**SOAH DOCKET NO. 473-21-0247
PUC DOCKET NO. 51023**

APPLICATION OF THE CITY OF SAN ANTONIO TO AMEND ITS CERTIFICATE OF CONVENIENCE AND NECESSITY FOR THE SCENIC LOOP 138-KV TRANSMISSION LINE IN BEXAR COUNTY §
§
§
§
§
§

**CPS ENERGY'S RESPONSE TO
COMMISSION STAFF'S FIRST REQUEST FOR INFORMATION**

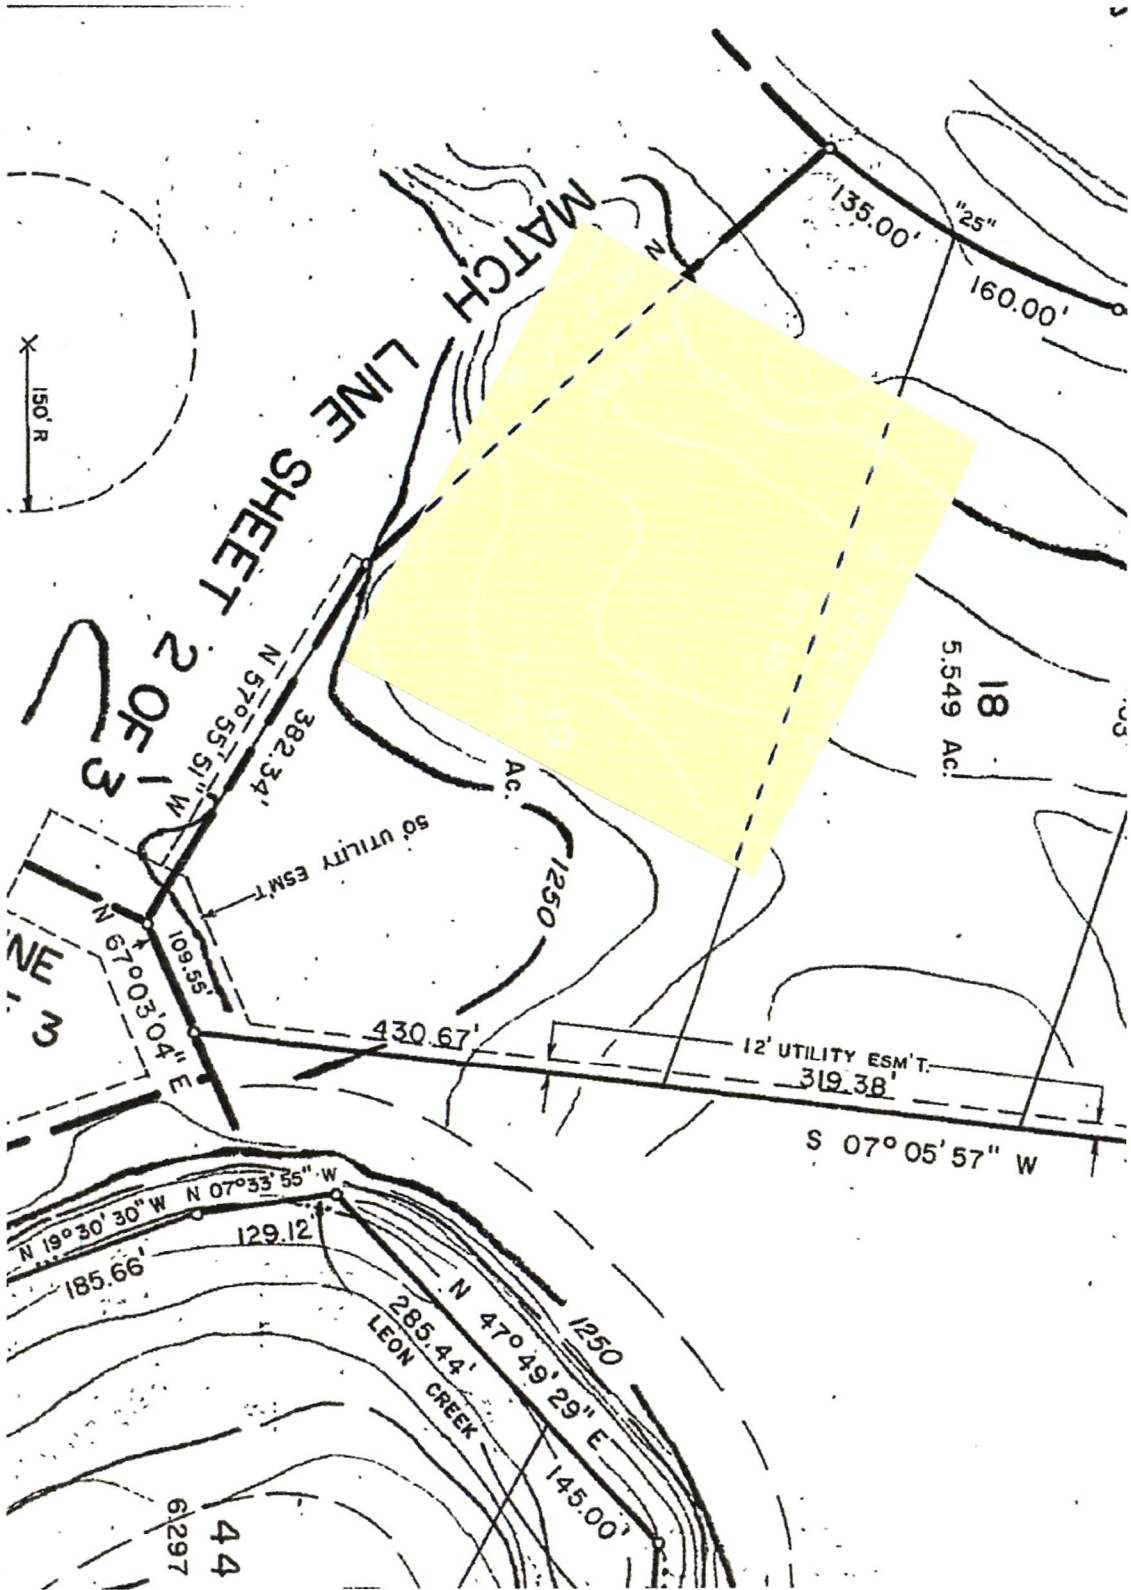
Please admit or deny that the distance between Segment 42 and the outdoor areas accessible to children at Dr. Sara B. McAndrew Middle School is less than 323 feet.

The school referenced in this question is the Dr. Sara B. McAndrew Elementary School. Based on fencing and other indications of potential property use, the distance between proposed Segment 42 and the closest corner of an outdoor area on the elementary school property that POWER Engineers, Inc. believes may be accessible to children on a regular basis is approximately 335 feet to the area with playground structures and approximately 280 feet to the grass area with a baseball/kickball backstop in the southwest corner of the elementary school property.

Figure 1-6

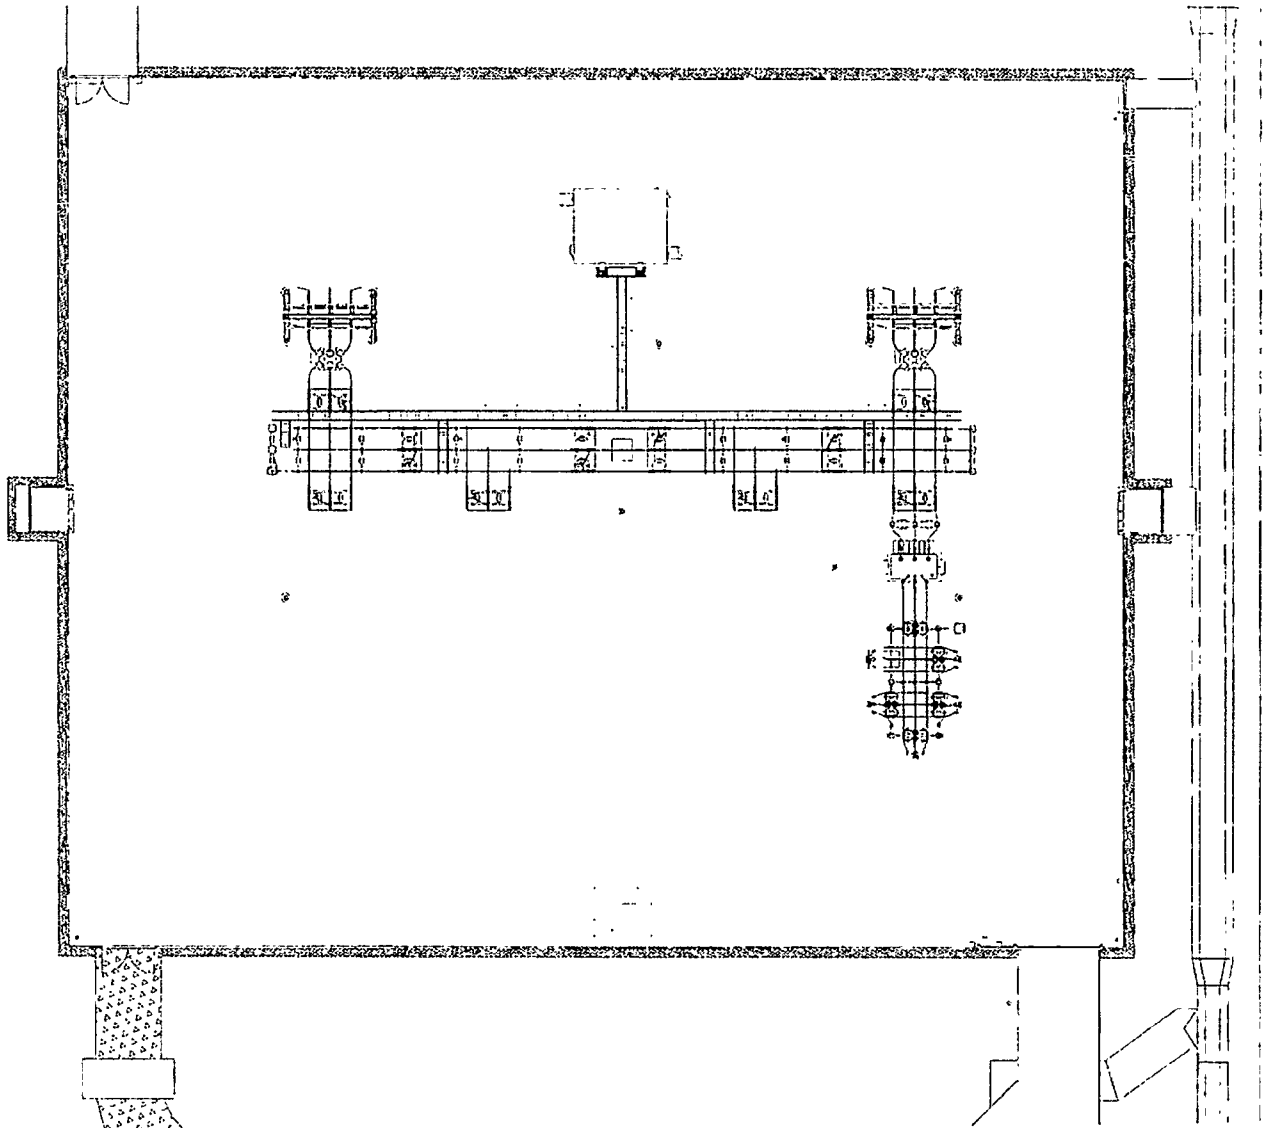
Regarding AS 2-16 and 2-17, substation site 7, parcel A-078 is just slightly larger than 7 acres and is irregularly pie shaped with a maximum width of just over 400 feet. CPS figure 1-6 shows a squarish boundary with equal clearance to the fence for all components. How would altering CPS standard design to fit within this narrow parcel change the response to these RFI's? Would the entire parcel need to be clear cut of all vegetation? Would the substation security fence generally be located at the lot lines, and is there any setback required for perimeter fencing?

Regarding Substation Site 7, please provide a detailed sketch showing the dead-end transmission structure, the substation site, including fence and lights. Please describe the security lighting heights and wattage and the hours of illumination proposed for the Substation Site 7 or, if not yet proposed, typically used by CPS.

If Substation Site 7 is an endpoint of a route approved by the Public Utility Commission of Texas for the Project, the substation facilities will be designed and constructed on the property in a way that minimizes the footprint on the property and leaves as much of the existing vegetation as possible for a visual buffer. No “clear cutting” is anticipated. Based on CPS Energy’s current understanding of the property without the benefit of on the ground surveys, it is anticipated the substation facilities will be constructed in the center area of the property.

CPS Energy is not aware of any setback requirements that will be applicable to the construction and operation of substation facilities on Substation Site 7.

It is presently anticipated that approximately eight foot high chain-link security fencing will be installed around the perimeter of the substation equipment (i.e., not at the lot line). If Substation Site 7 is utilized for the project, CPS Energy will evaluate if a lower barbed wire property line fence is also appropriate.

The site layout for a substation at Substation Site 7 has not yet be designed. Figure 1-6 in Attachment 1 to the Application is the general proposed substation layout. Appendix B to Attachment 1 to the Application includes pictures of CPS Energy substations that will be generally similar to the substation facilities that are proposed to be constructed for this Project, (see Bates Pages 310, 311, 312, 313, 316, and 320).

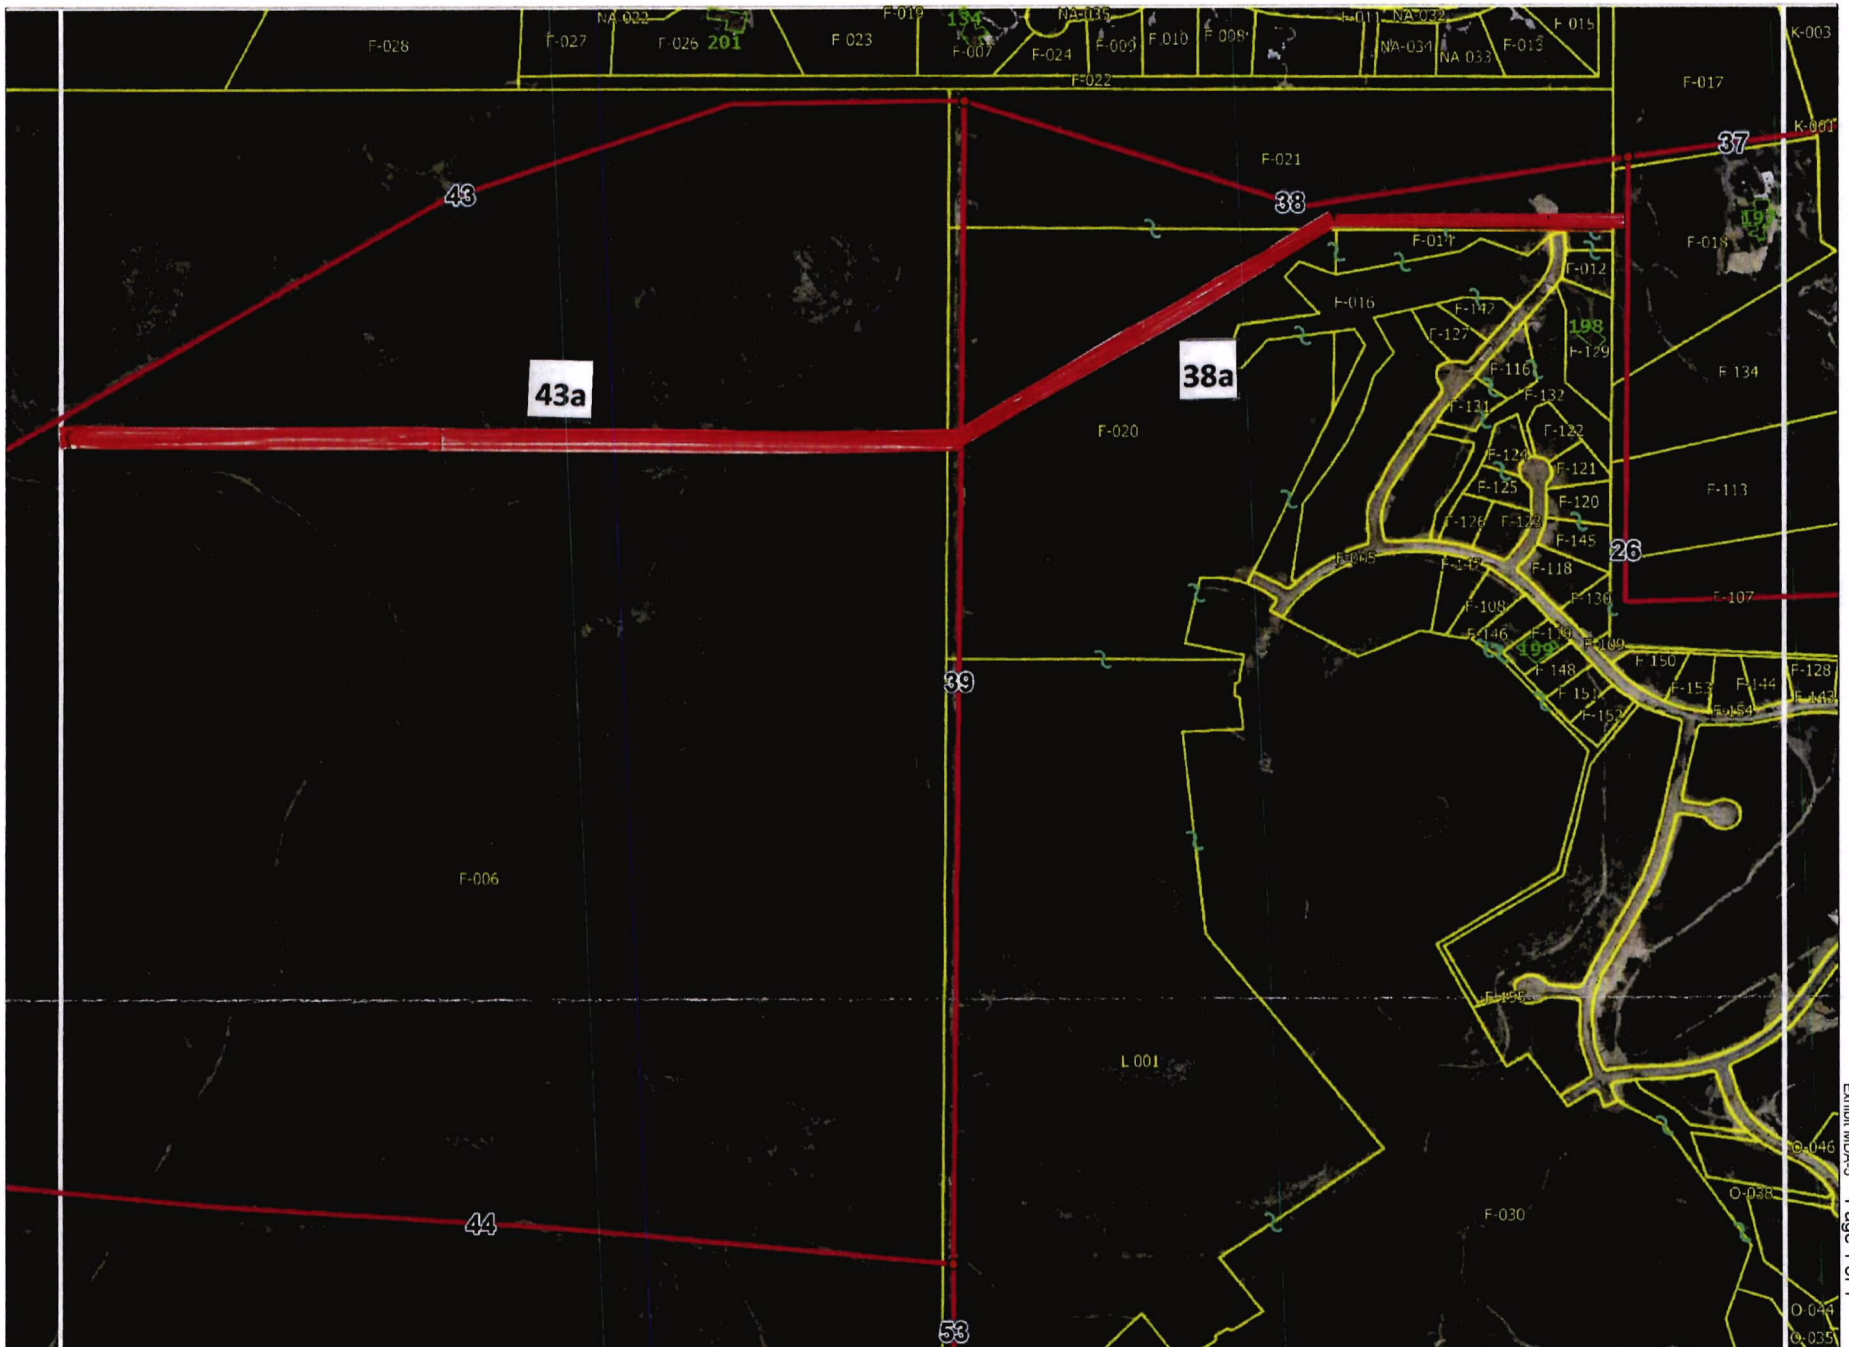
AS-1-1 Please provide the date construction started on the structure circled on the Aerial Photograph.

Response: On or about February 25, 2020.
